VSP-23  
September 25, 1980

Subject: Avco Lycoming Service Bulletin No. 450  
(AiResearch Service Bulletin No. TP60-0119)

# SERVICE BULLETIN

SUBJECT: BYPASS VALVE MODIFICATION

Figure 1. Affected parts in installation of Piston, Packing (U-Cup) and Expander

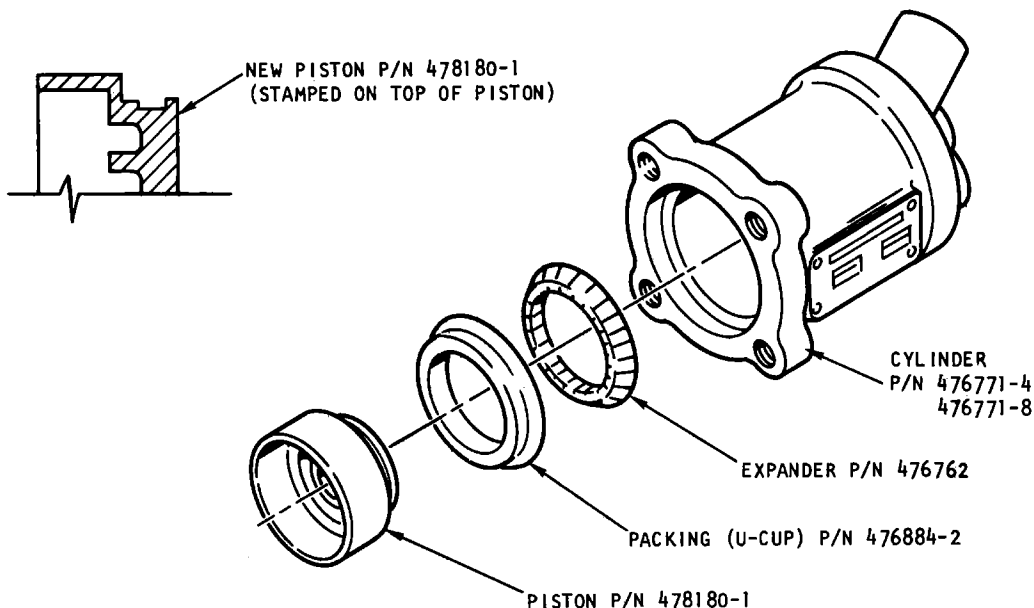
7. Using packing (U-Cup) insertion tool, P/N 410070, install piston, P/N 478180-1; packing (U-Cup), P/N 476884-2; and expander, P/N 476762 back into cylinder as shown in Figure 1. Insert the new piston, packing (U-Cup), and expander (as a unit) into top (widest opening) of U-Cup insertion tool. Position insertion tool into cylinder bore, and tool should be rotated while inserting piston assembly into cylinder, to center piston. Stroke piston by hand three to four times to assure packing (U-Cup) is moving freely prior to reassembling cylinder to cylinder plate.

5. Using new piston P/N 478180-1, install new packing (U-Cup) P/N 476884-2, and expander P/N 476762 onto piston.
6. Pre oil bore of cylinder and outside lip of packing (U-Cup), and inside of packing (U-Cup) insertion tool.

Figure 2. Cylinder Assembly Leak Test Points

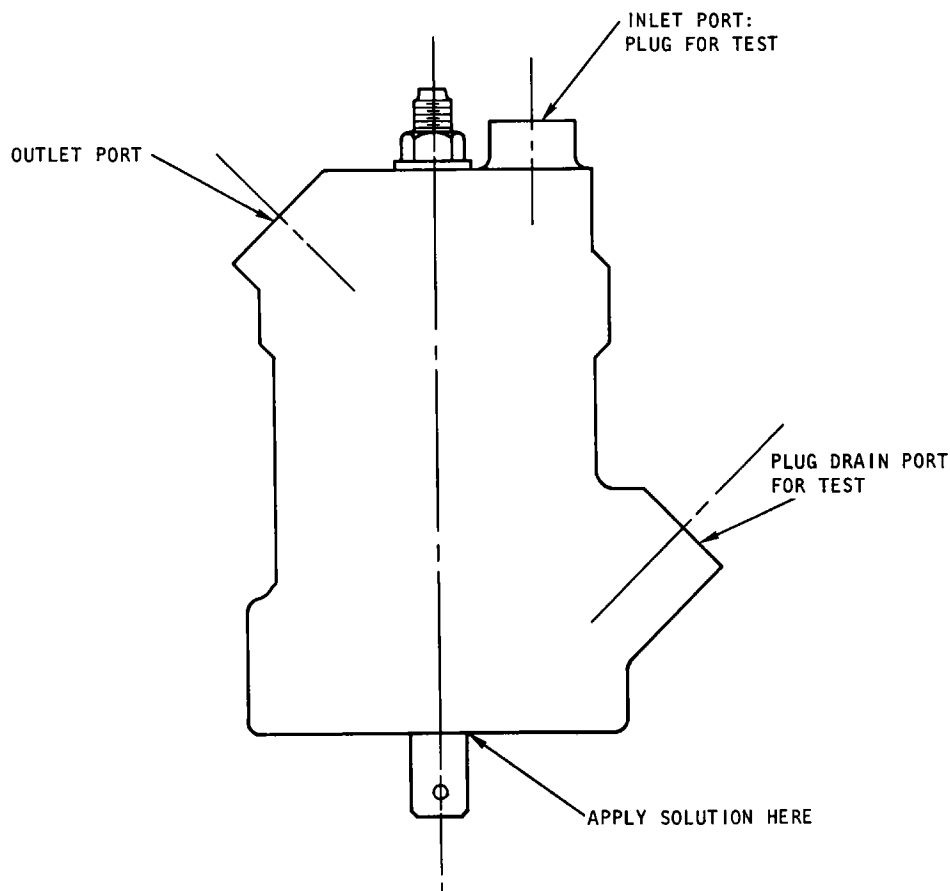
- c. Apply leak detection solution to area indicated in Figure 2.
- d. Observe leakage at specified point. Clean and inspect if leakage rate exceeds one bubble in 15 seconds. If leakage rate is still one bubble in 15 seconds, replace with new packing (U-Cup) P/N 476884-2.
- e. Repeat steps b, c, and d with  $60 \pm 2$  psig applied to the outlet.
